**2<sup>nd</sup> Further Information**

**Proposed Temporary Warehouse (excluding Dangerous Goods Godown) with Ancillary Facilities  
for a Period of 3 Years and Associated Filling of Land in "Agriculture" Zone,  
Various Lots in D.D. 107, Fung Kat Heung, Yuen Long, New Territories**

**(S.16 Planning Application No. A/YL-KTN/1033)**

**Responses-to-Comments**

DWG NO. PLAN 1	VER. 002
-------------------	-------------

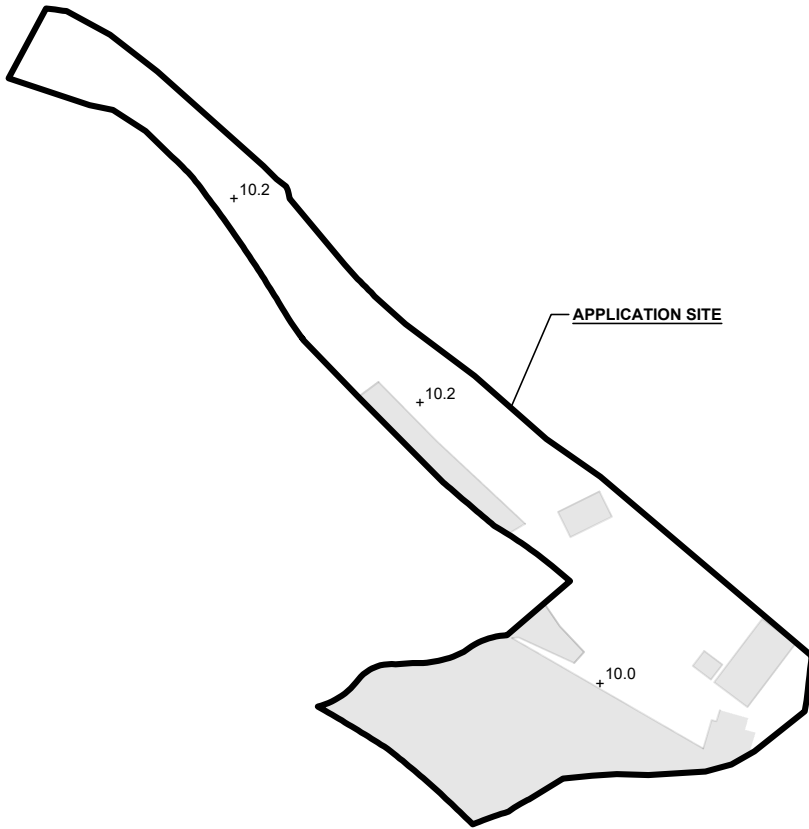
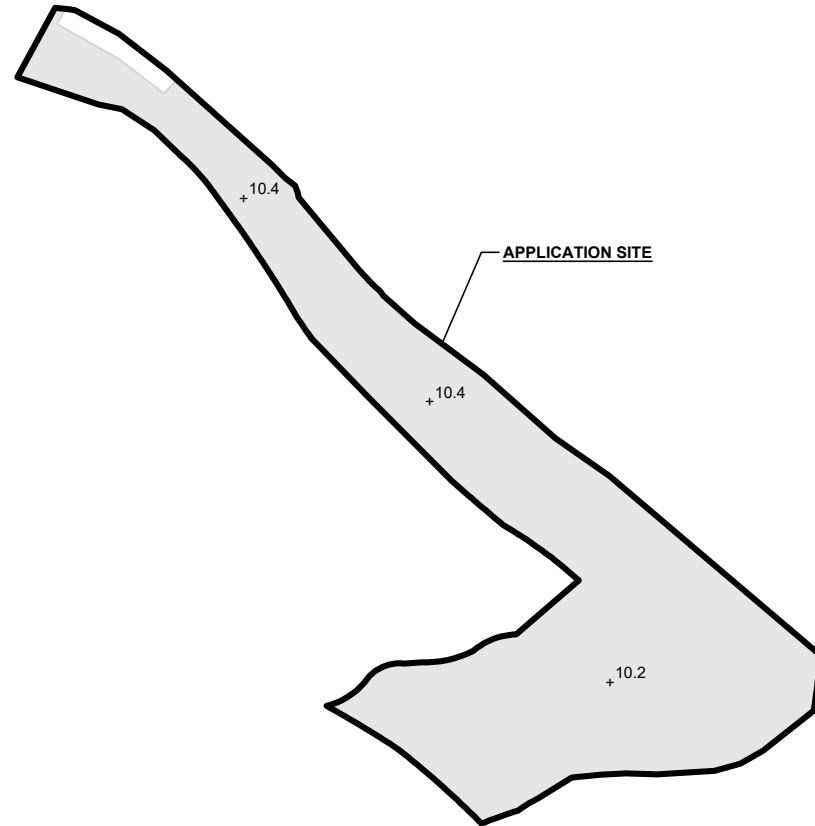
(a)	In your land filling plan (plan 5), it is noted that the entire site is hard-paved. However, during our recent site visit, we observed that some areas of the Site remain unpaved.	A revised plan showing the filling of land of the Site is provided ( <b>Plan 1</b> ). About 895m <sup>2</sup> (i.e. 37%) of the Site has already been hard-paved. All the existing hard-paved area will be removed by the applicant after planning approval has been obtained from the Board.

(b)	Please provide clarification regarding the areas designated for filling and regularisation of land, respectively (including %) and rectify relevant plan(s). Since five new trees are proposed to be planted along the northwest periphery boundary of the Site in your landscape proposal, please consider this when calculating the proposed area for filling and regularisation of land.	Majority of the Site (i.e. 2,382m <sup>2</sup> , 98%) is proposed to be filled with concrete of not more than 0.2m in depth for site formation of structure and circulation space. The remaining area will remain as soiled ground for healthy tree growth.

- (i) A revised plan showing the filling of land of the application site (the Site) is provided (**Plan 1** and **Annex I**). About 895m<sup>2</sup> (i.e. 37%) of the Site has already been hard-paved. All the existing hard-paved area will be removed by the applicant after planning approval has been obtained from the Town Planning Board (the Board). Majority of the Site (i.e. 2,382m<sup>2</sup>, 98%) is proposed to be filled with concrete of not more than 0.6m in depth for site formation of structure and circulation space. The remaining area will remain soiled ground for healthy tree growth.
- (ii) A RtoC Table:

*ALL THE EXISTING HARD-PAVING AREA WILL BE REMOVED BY THE APPLICANT. THE SITE WILL BE FILLED TO THE PROPOSED SITE LEVEL AFTER PLANNING PERMISSION HAS BEEN OBTAINED FROM THE TOWN PLANNING BOARD*

DWG NO.: ANNEX IV VER.: 002

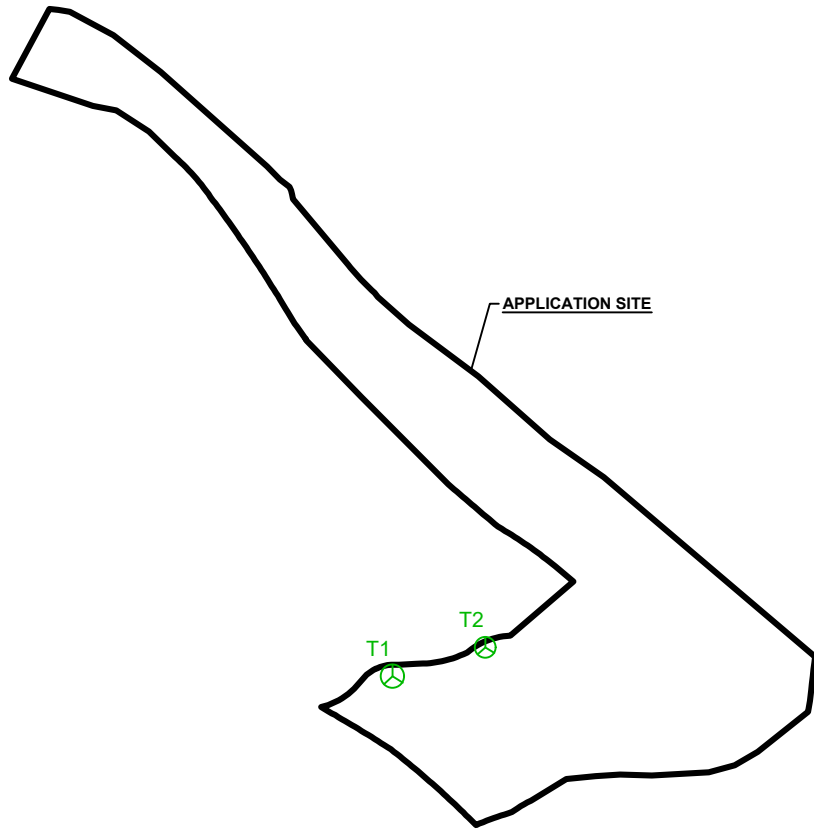
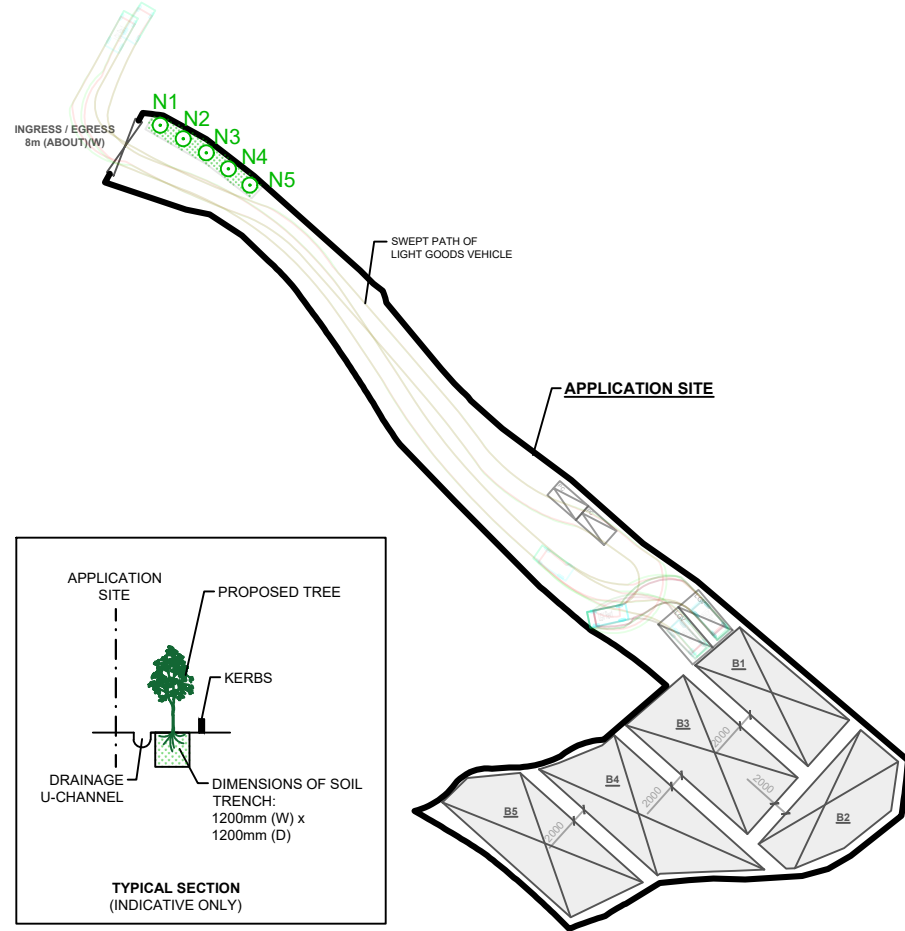
(a)	Some existing mature trees of common species are observed within the site. According to the layout plan (Plan 4), the proposed structure B2 and land filling works may be in conflict with the existing trees. With no tree information, proposed tree treatment, mitigation measure provided in the application, potential impact on the existing landscape resources within the site arising from the proposed use could not be reasonably ascertained.	According to the tree survey conducted on 30/8/2024, <u>2</u> trees (T1 to T2) are recorded within the Site ( <b>Annex II</b> ). No old and valuable tree or protected species has been identified in accordance with DEVB TC(W) No. 5/2020 – Registration and Preservation of Old and Valuable Trees and the Forests and Countryside Ordinance (Cap. 96). Due to the proposed hard-paving works for site formation of structures and circulation purposes, all the existing trees will be affected, and it is not proposed to retain any of the existing trees within the Site. A photographic record showing the existing condition of the Site is provided ( <b>Annex III</b> ).

(b)	The applicant is advised to provide information on the existing trees within the application site including location, species and sizes, general condition with photos, proposed tree treatment and mitigation measures for consideration.	Due to the proposed tree felling at the Site, a landscape proposal is submitted by the applicant to provide landscape mitigation measures for the proposed development ( <b>Annex IV</b> ). A total of <u>5</u> new trees (N1 to N5), with continuous soil trench, are proposed to be planted along the northwest periphery boundary of the Site as indicated on plan, to

(c)	It is noted that the root of the existing tree located in the center of the site is restricted by concrete paving. The applicant should remove the concrete paving for the sustainable growth of tree.

minimise adverse visual impact to the adjoining receivers ( <b>Annex IV</b> ). All the new trees within the Site will be maintained by the applicant during the planning approval period.
